Access Compliance Report

Public Rights-of-Way

(Curb Ramps)

Intersection ID: 22158	Main Street: LILLY_MILL_RD	Cross Street: WHIFFLETREE_RD	Location: SE
ADA ID: EC2EF50945F9	Ramp Type: PerpDiag	Initial Pass/Fail: Fail	Overall Compliance: No
		Severity Score: 50

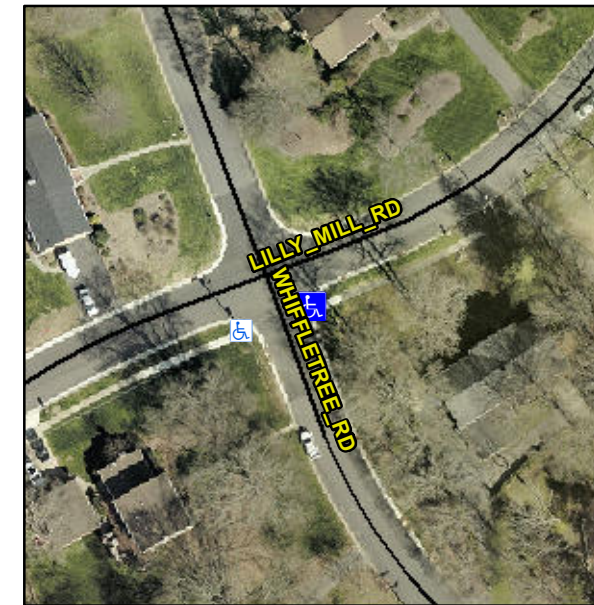
Not Found, R304.2.2, R304.5.3

Compliance	Description	Data	Compliance	Description	Data
N/A	Ramp Length (in)	61.5	No	Ramp Slope (%)	14.1
Yes	Ramp Width (in)	48.1	No	Ramp XSlope (%)	7.6
N/A	Flare Type LT	N/A	N/A	Flare Type RT	N/A
N/A	Flare Slope LT (%)	N/A	N/A	Flare Slope RT (%)	N/A
N/A	Flare Traversable LT?	N/A	N/A	Flare Traversable RT?	N/A
N/A	Landing Length (in)	N/A	N/A	DWS Provided?	N/A
N/A	Landing Width (in)	N/A	N/A	DWS Contrast?	N/A
N/A	Landing Slope (%)	N/A	N/A	DWS Length (in)	N/A
N/A	Landing X Slope (%)	N/A	N/A	DWS Full Width?	N/A
N/A	Landing Curb? (Y/N)	N/A	N/A	DWS Offset (in)	N/A
N/A	Shared Landing?	N/A			
N/A	Gutter Ponding?	N/A	N/A	Gutter Slope (%)	N/A
N/A	Gutter Lip Ht (in)	N/A	N/A	Gutter X Slope (%)	N/A
N/A	Painted X Walk1?	No	N/A	Painted X Walk2?	No
	X Walk 1 Direction	To N		X Walk 2 Direction	To W
N/A	X Walk 1 Width (in)	N/A	N/A	X Walk 2 Width (in)	N/A
	X Walk 1 Slope (%)	6.2		X Walk 2 Slope (%)	8.1
	X Walk 1 X Slope (%)	9.9		X Walk 2 X Slope (%)	3.5

Remove & Replace Curb Ramp With Two New Directional Ramps or Equivalent.
